Radiological Health Review
of the Draft Environmental Impact Statement (DOE/EIS-0026-D)
Waste Isolation Pilot Plant, U. S. Department of Energy

Robert H. Neill, James K. Channell, Carla Wofsy,
Moses A. Greenfield, Editors

Environmental Evaluation Group
Environmental Improvement Division
Health and Environment Department
State of New Mexico

August 1979

Figure 1

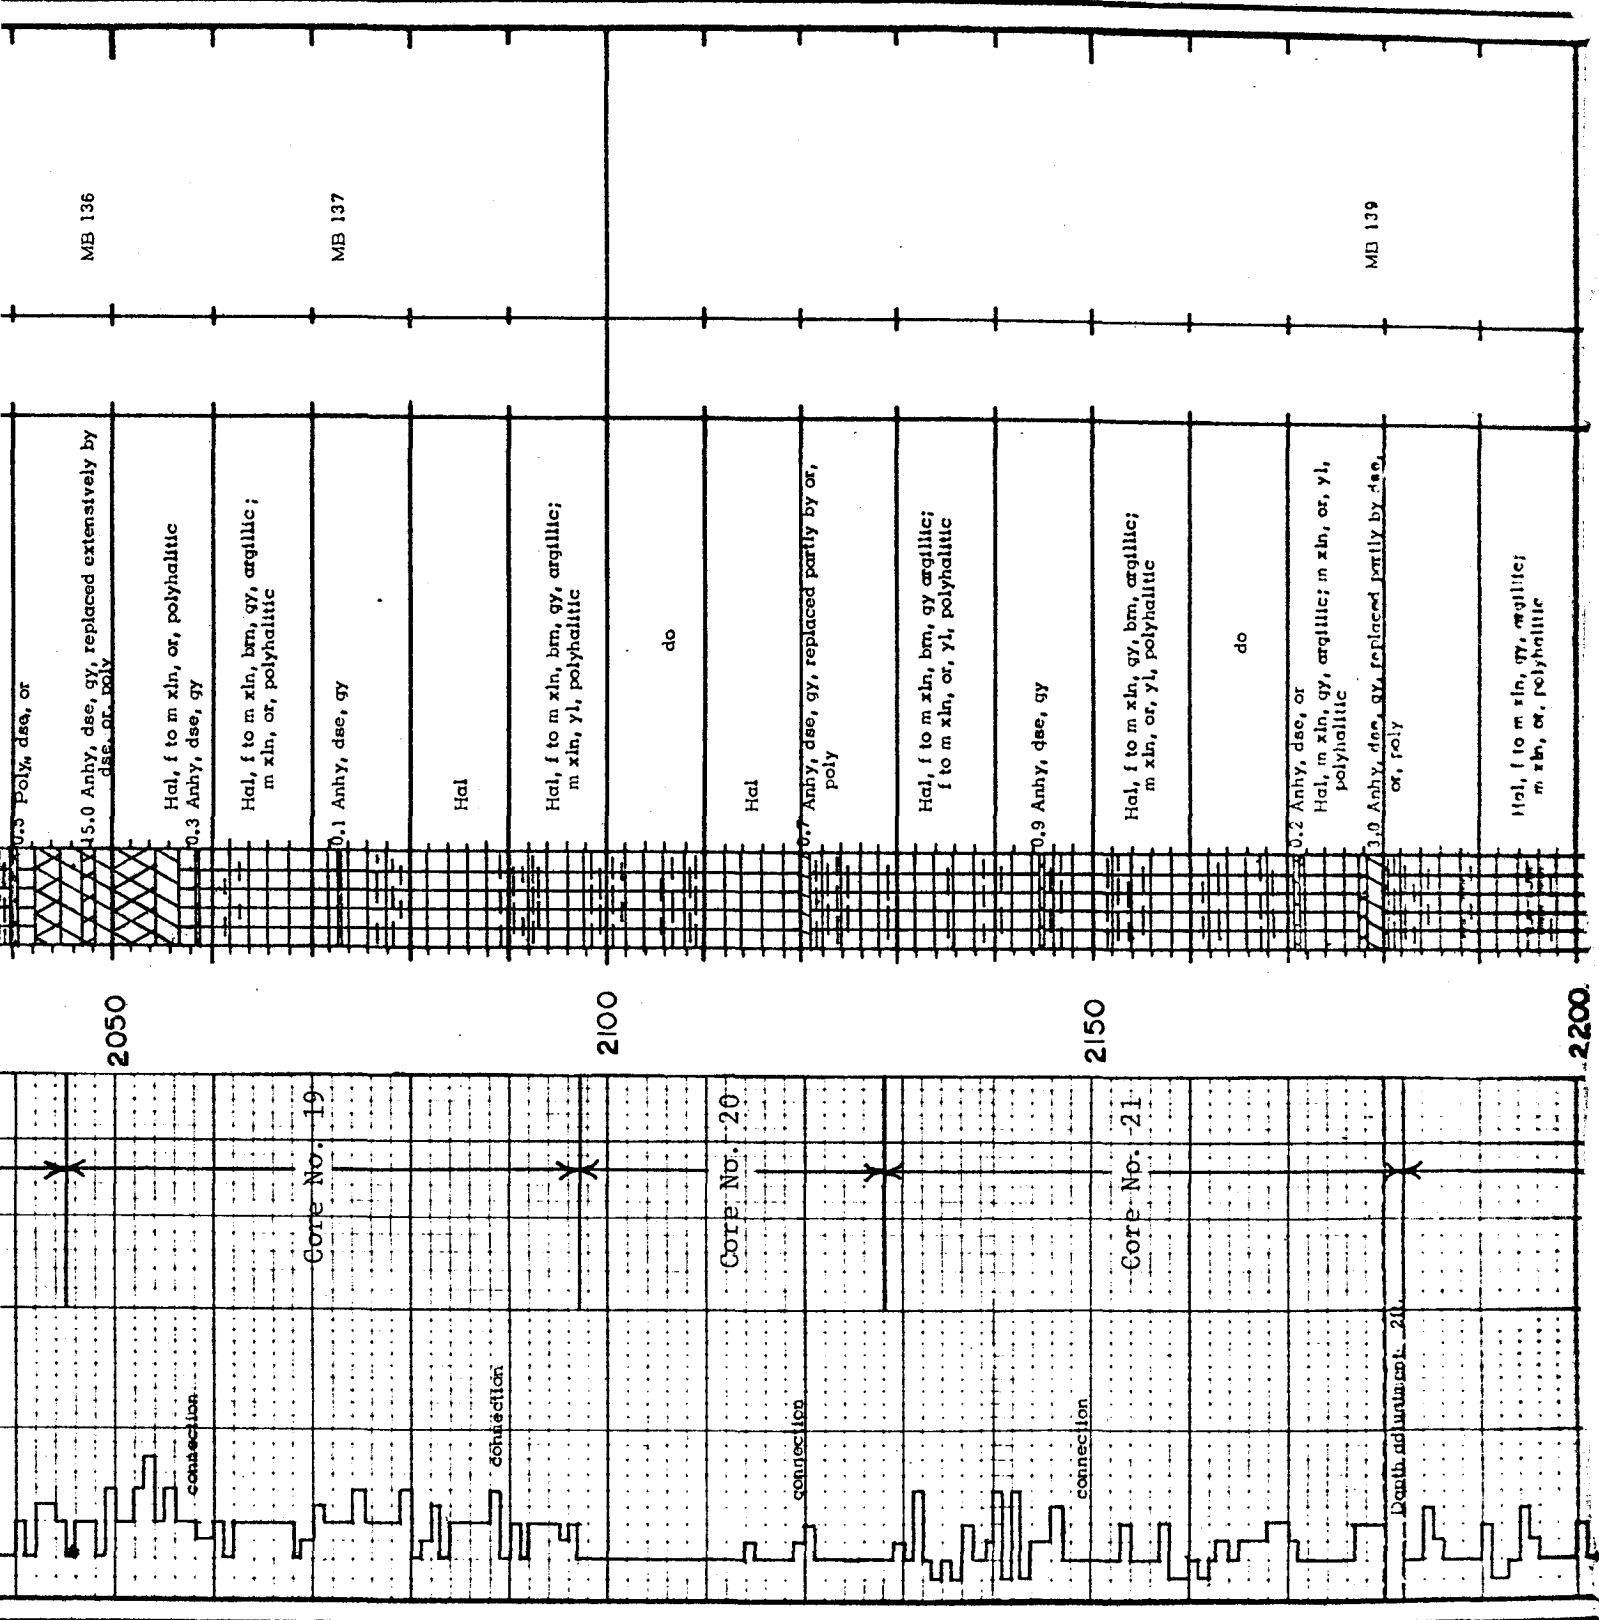
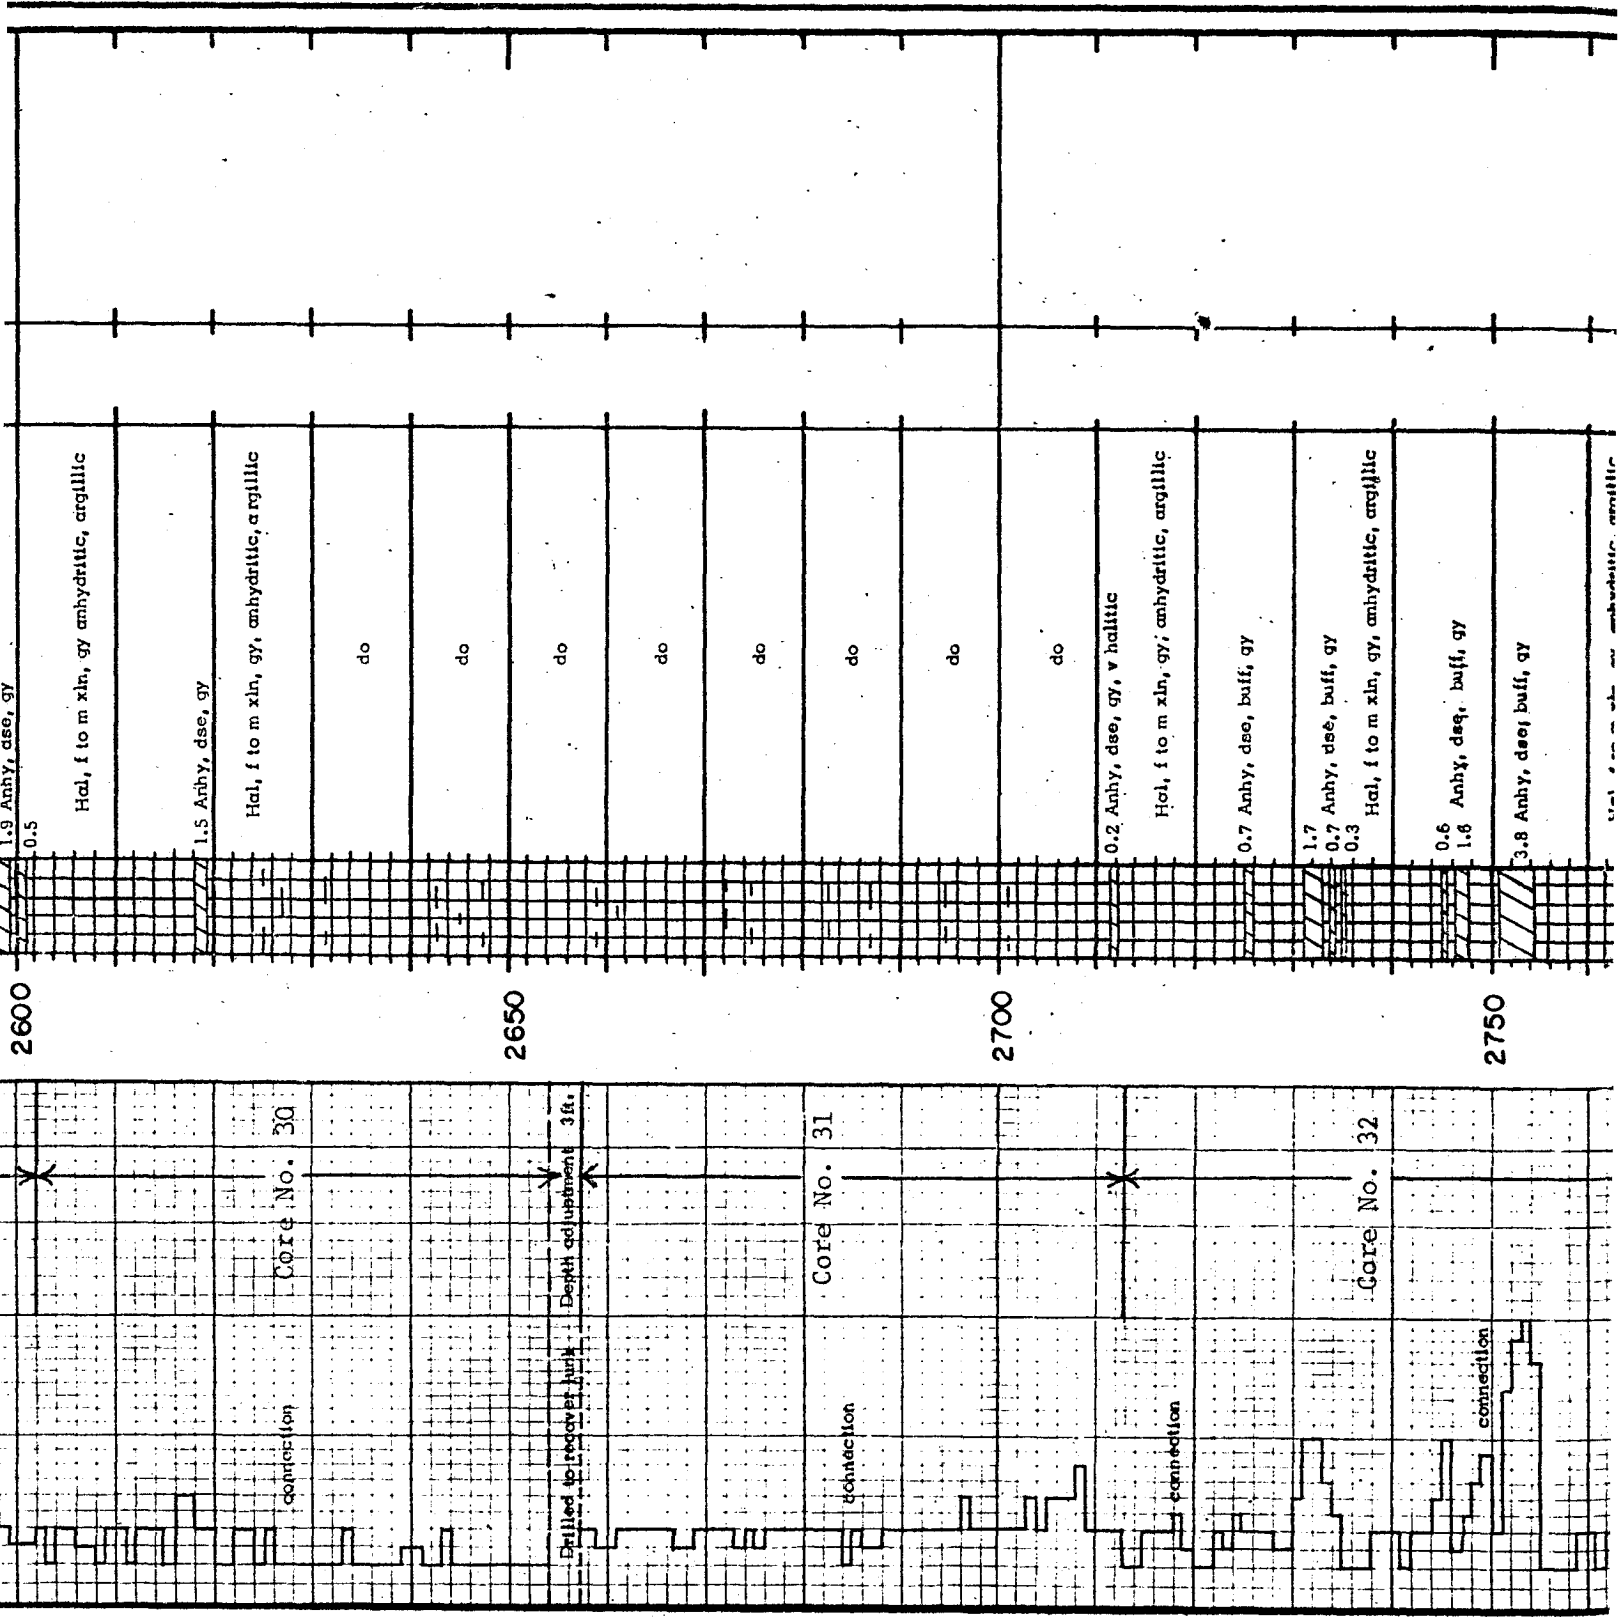
- 4) The lithology of the repository horizons is described on page 7-24 of the DEIS and parts of the lithologic log of the ERDA-9 hole are shown in Figures 1 and 2 of this section (from Fig. 4.3-3B of the GCR). These sections of the logs describe the lithology of the repository horizons for CH and RH zones as shown on Figure 4.3-3A of the GCR. The logs show the presence of clay, anhydrite and polyhalite in addition to halite, as the constituents of both repository horizons. The presence of these impurities should be taken into account in evaluating physical, hydrological, thermal and strength characteristics of "rock salt" from the repository horizons.

Figure 1

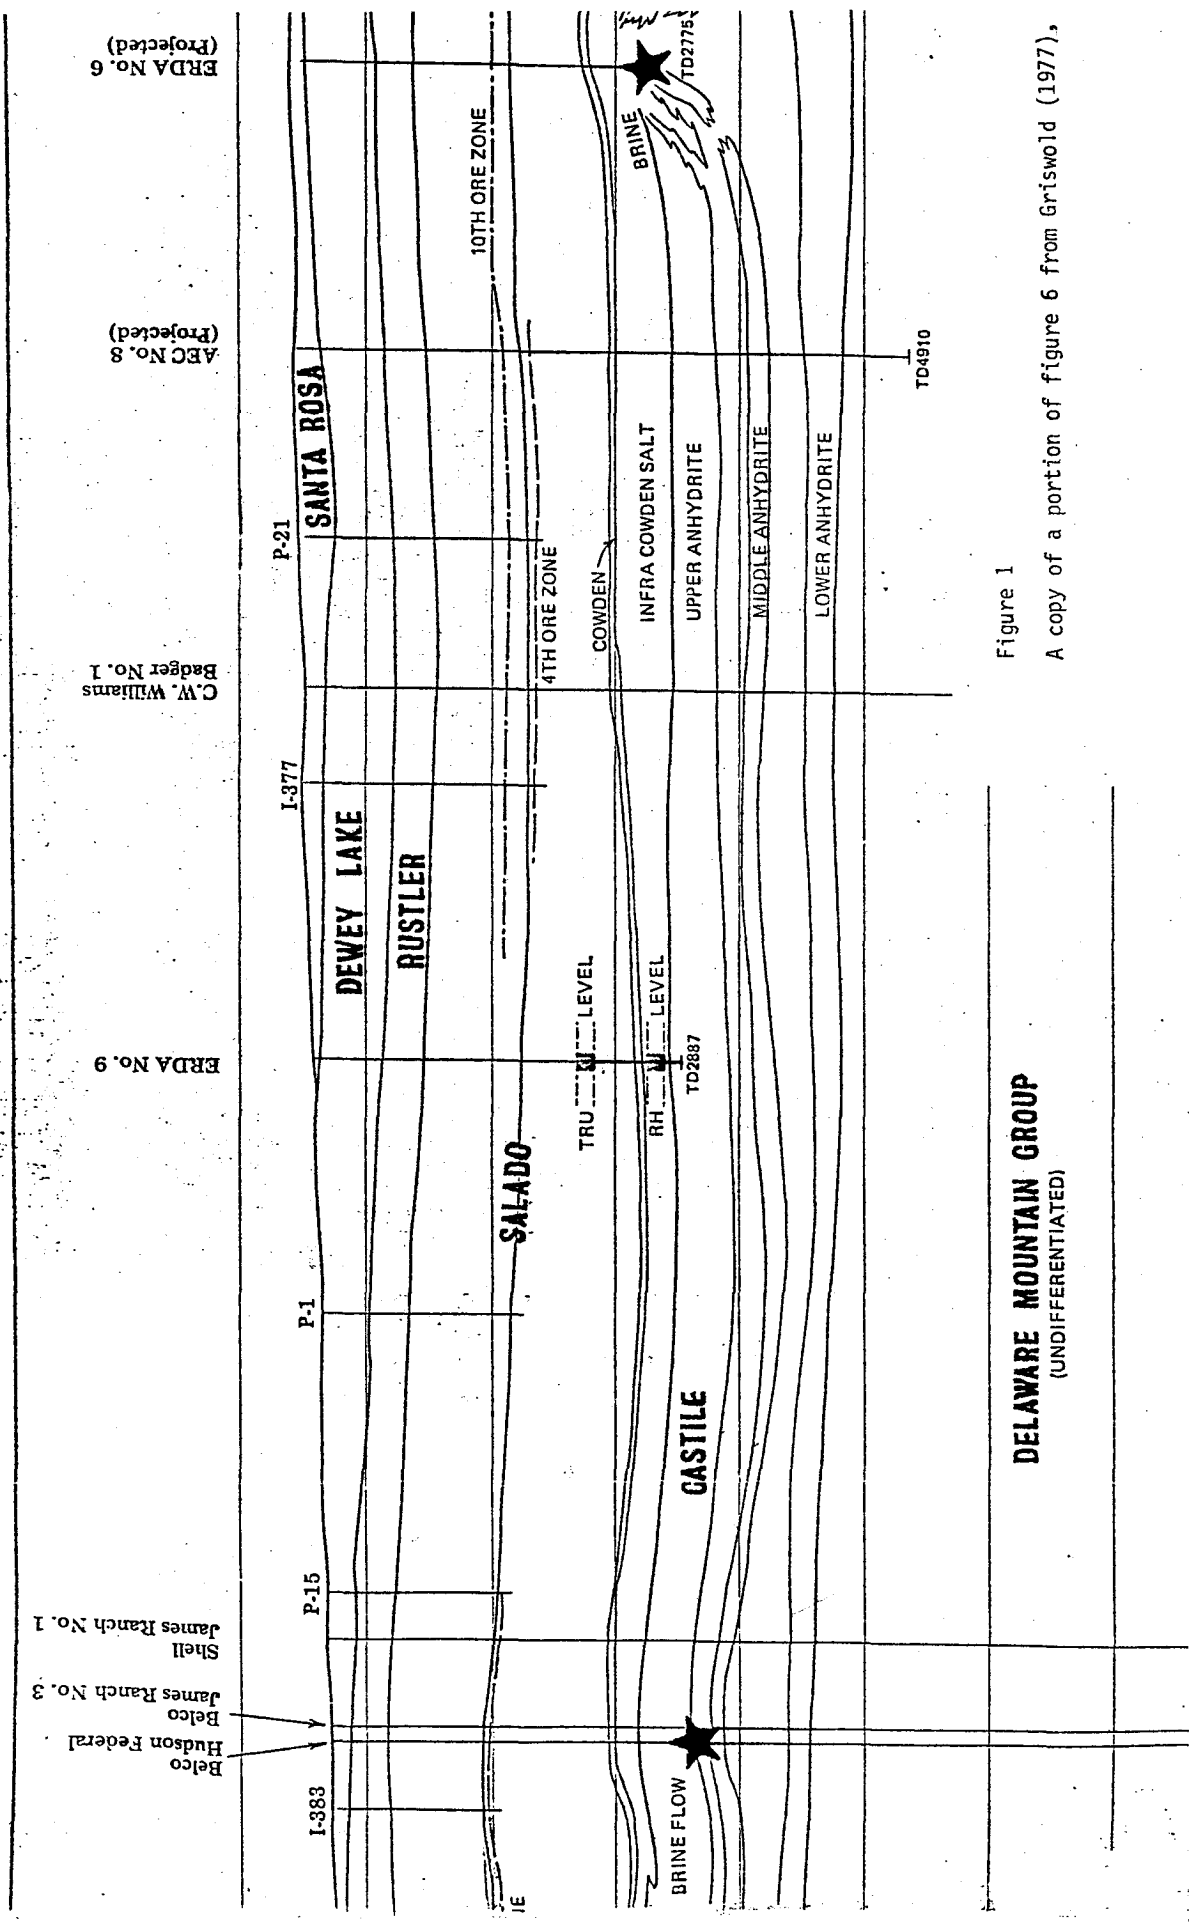
Capitan reef. Griswold's Figure 6 (see Figure 1) graphically demonstrated the stratigraphic position of these brine flows in relationship to the proposed repository.

Brine reservoirs occur in the Castile formation which is directly below the Salado formation where the repository would be located and the brine reservoir at the ERDA No. 6 location has intruded locally up to the level of the lower part of the Infracowden salt. The origin, occurrence and configuration of these brine reservoirs are not adequately addressed in the GCR. For example, the geochemical analyses of the ERDA No. 6 brine are generally inconclusive with regard to the origin and period of isolation of the brine (see Section 6). It is conceivable that stress changes due to repository con-

struction and/or heat generating wastes in combination with the high pressure in an underlying brine reservoir could induce deformation and fracturing which would release brine into the repository. In view of the large flows and volumes, high pressures, and accompanying H₂S of these reservoirs, they need to be characterized in detail in order to assess their role as a potential threat to health, safety and environment. Finally, future resource exploration could conceivably penetrate an underlying brine reservoir and bring pressurized brine to the surface.

Figure 2
 Potentiometric
 Surface of Delaware
 Mountain Group Aquifer
 Note lack of observations
 in the crosshatched area.
 (from Fig. 6.3-1)

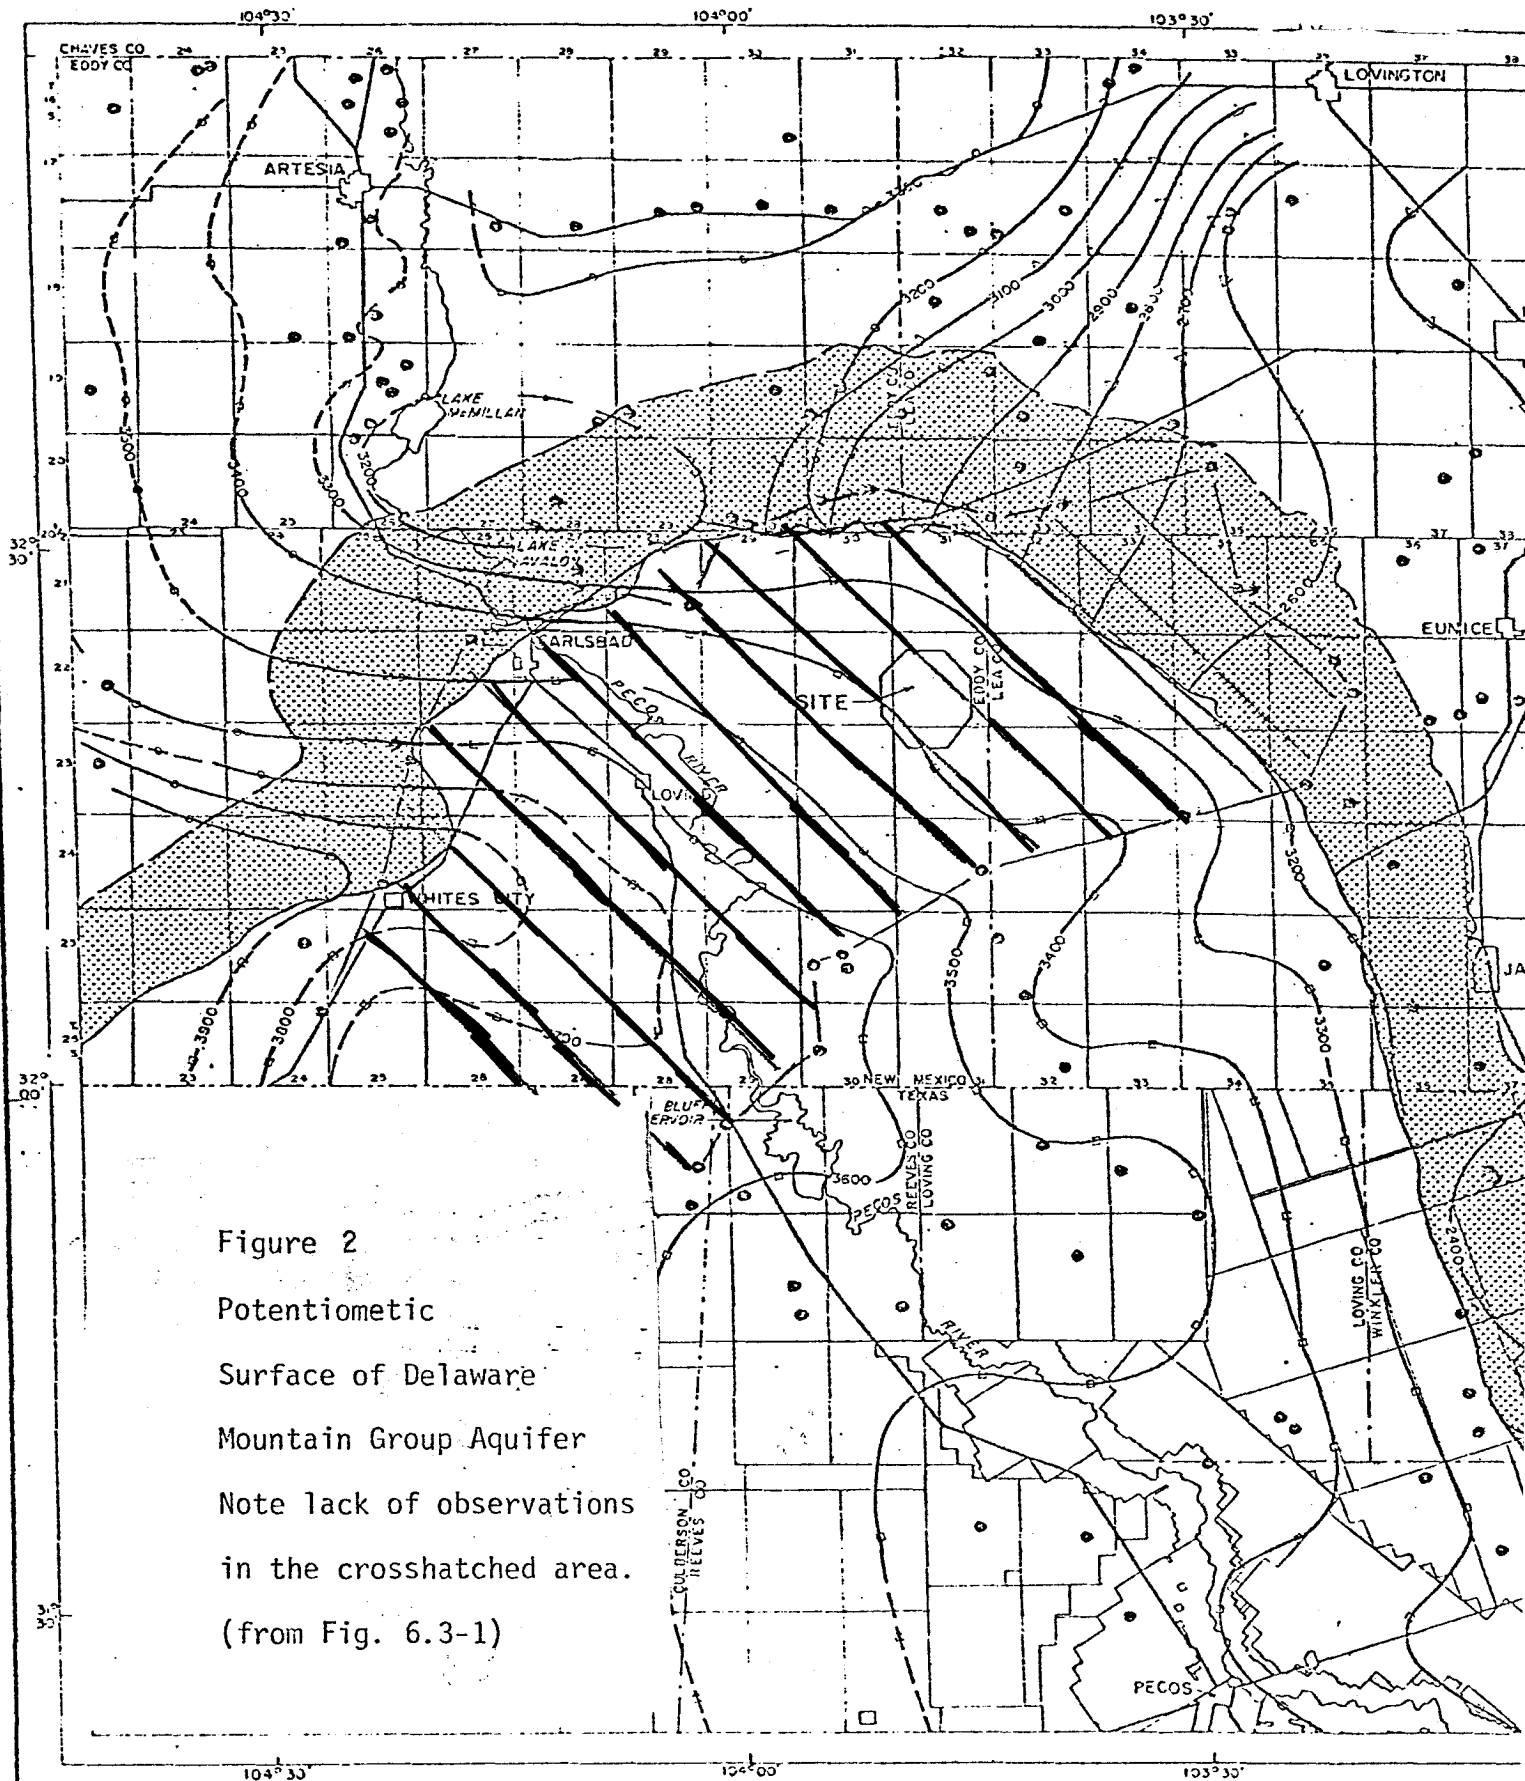
The underlying aquifer (Delaware Mountain Group) is discussed on (6-14); the potentiometric map for this aquifer (Fig. 6.3-1) is based on Hiss (1975). As shown in Figure 3, there is a large area around the site in which no well data were available. Are there additional data which could be included in
